Board of Adjustment

Staff Report

CASE NUMBER: BA15-006
STAFF PLANNER: Lesley Davis
LOCATION/ADDRESS: 1035 West Fairway Drive
COUNCIL DISTRICT: 1
OWNER: Mike and Sara Miller
APPLICANT: Kerry McNeil

REQUEST: *Requesting a variance to allow a detached structure to encroach into the required side and rear yard in the RS-9 zoning district. (PLN2015-00060)*

Site Plan

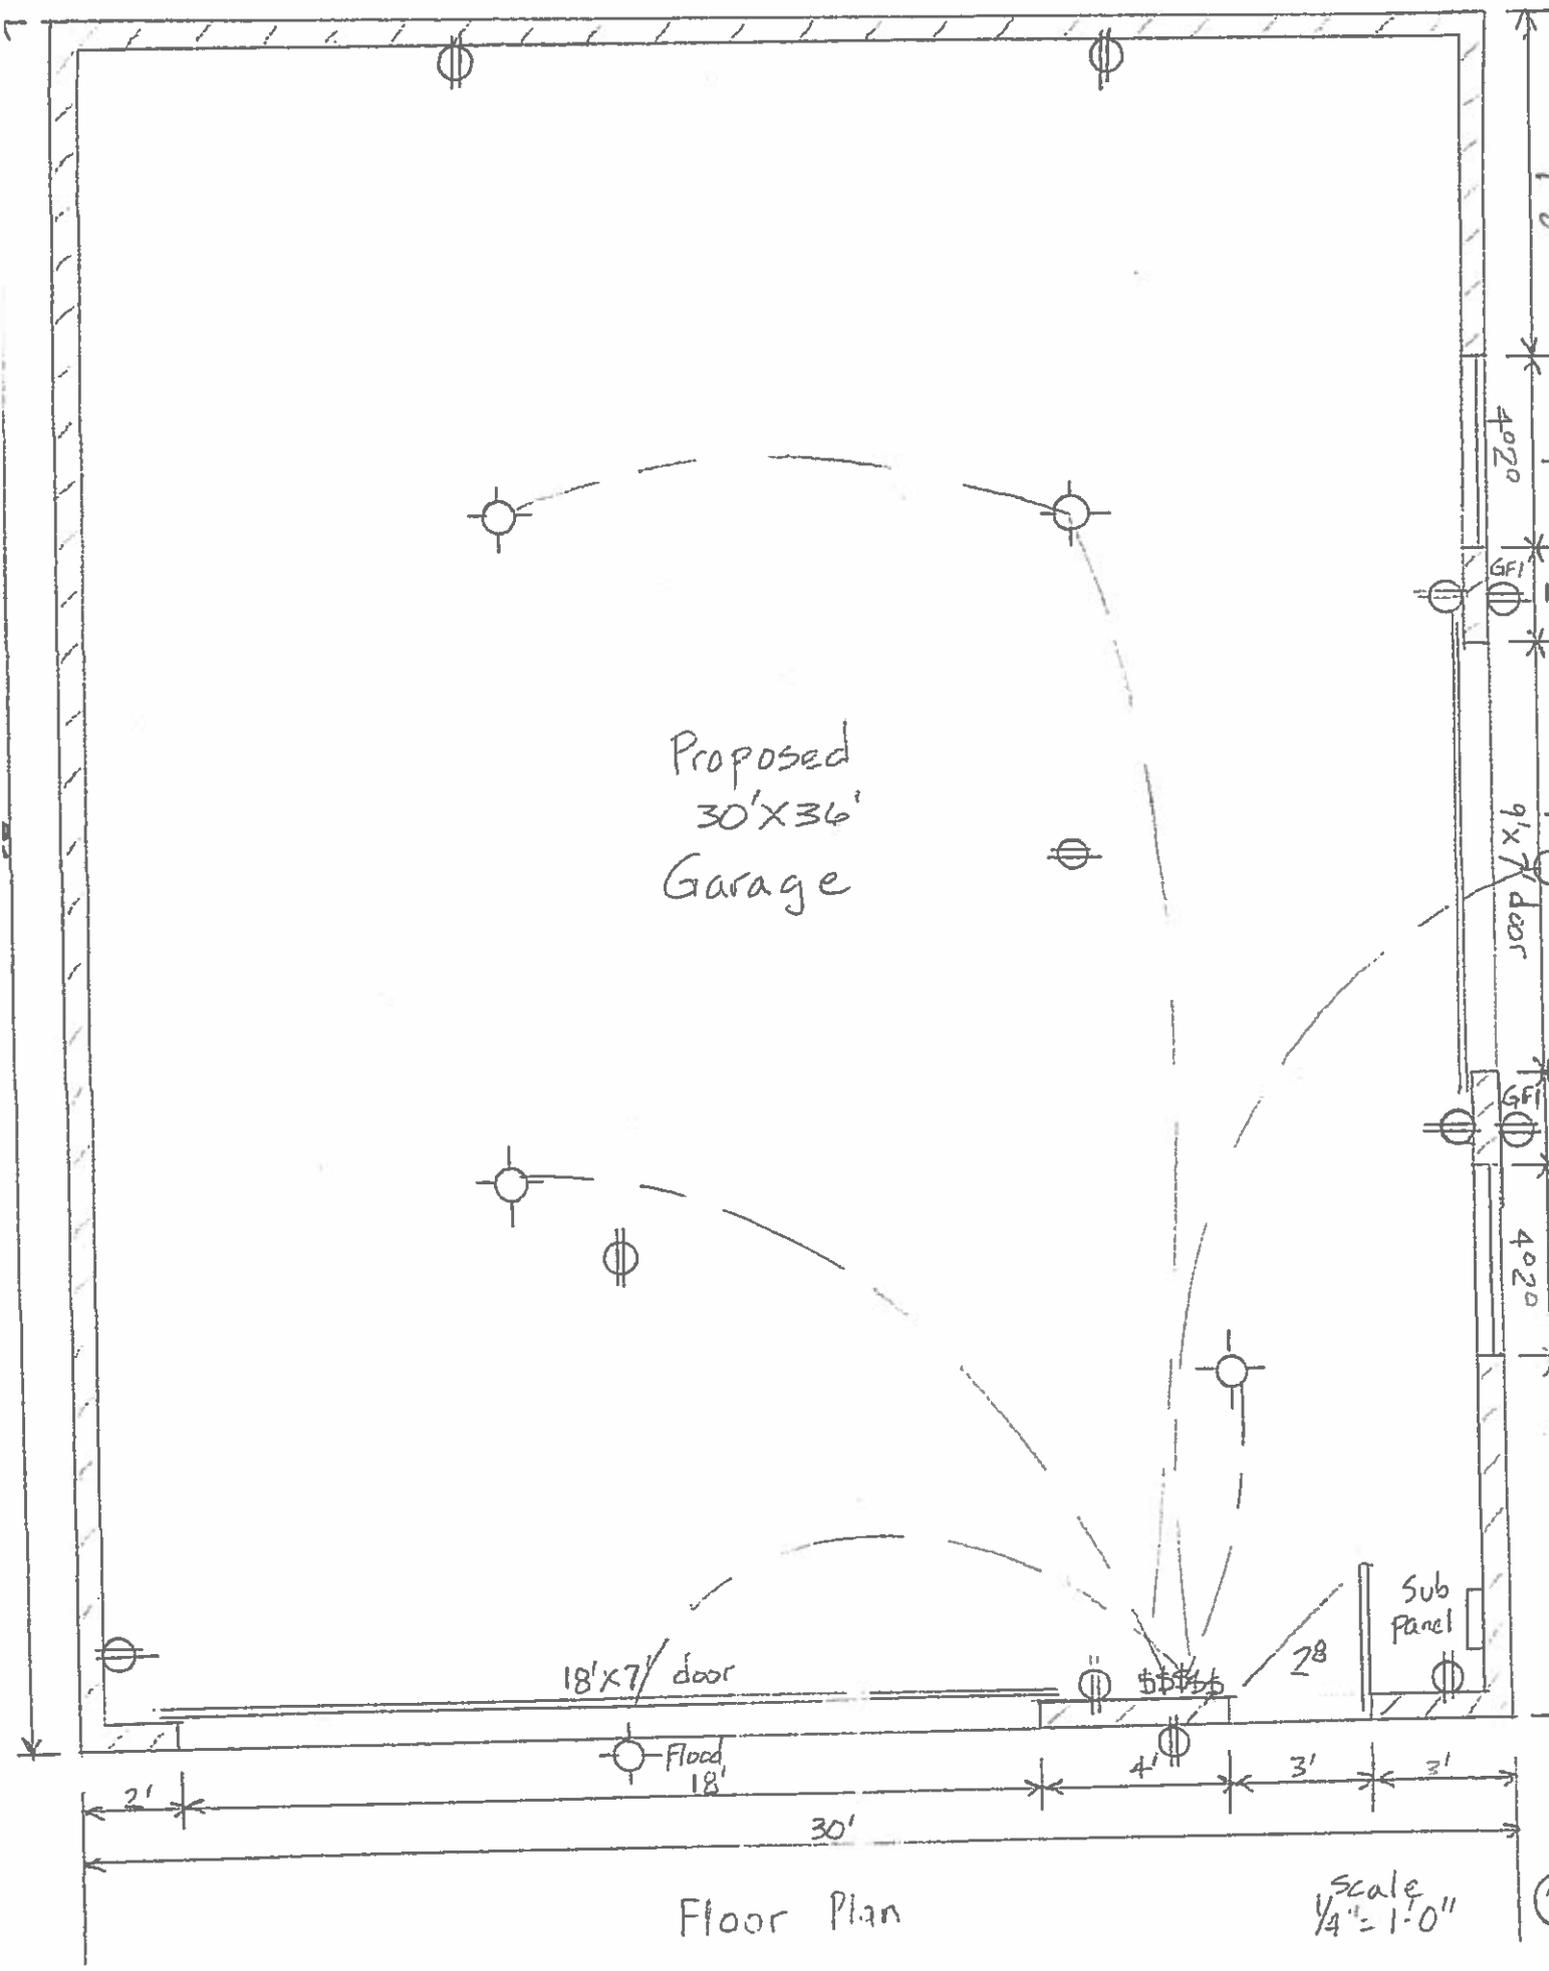
The applicant is requesting a variance to allow a detached garage to encroach four-feet into the required seven-foot side yard. As shown on the applicant's plans, the garage structure would be 41-feet wide and 40 and 43-feet deep (1,080 square-feet). The subject parcel is 18,709 square-feet and is located within the RS-9 Zoning District, which requires a minimum lot size of one acre. The proposed building is 11-feet, 4-inches high.

- 1.1 The proposed detached accessory building would result in a four-foot encroachment into the required seven-foot side yard in the RS-9 district.
- 1.2 The lot is 18,709 square-feet in size and has been developed in a manner similar to surrounding properties.

- 1.3 The lot size exceeds the minimum lot size in the R5-9 district, which is 9,000 square-feet in area
- 1.4 The lot appears to have sufficient area available for the construction of a detached garage without the need for a variance if it were narrowed by four-feet, which would either be a reduction in the square-footage or the structure's location could be adjusted so that it is further east and or south to maintain the desired square-footage.

- 1.6 The applicant has not provided sufficient justification related to the land, which would justify the degree of the requested variance.
- 1.7 Further, strict compliance with Code setback standards would not deprive the property of the ability to construct a detached building as there is sufficient area to the sides and rear of the property to accommodate detached or attached structures.

Staff recommends denial of case BA15-006.
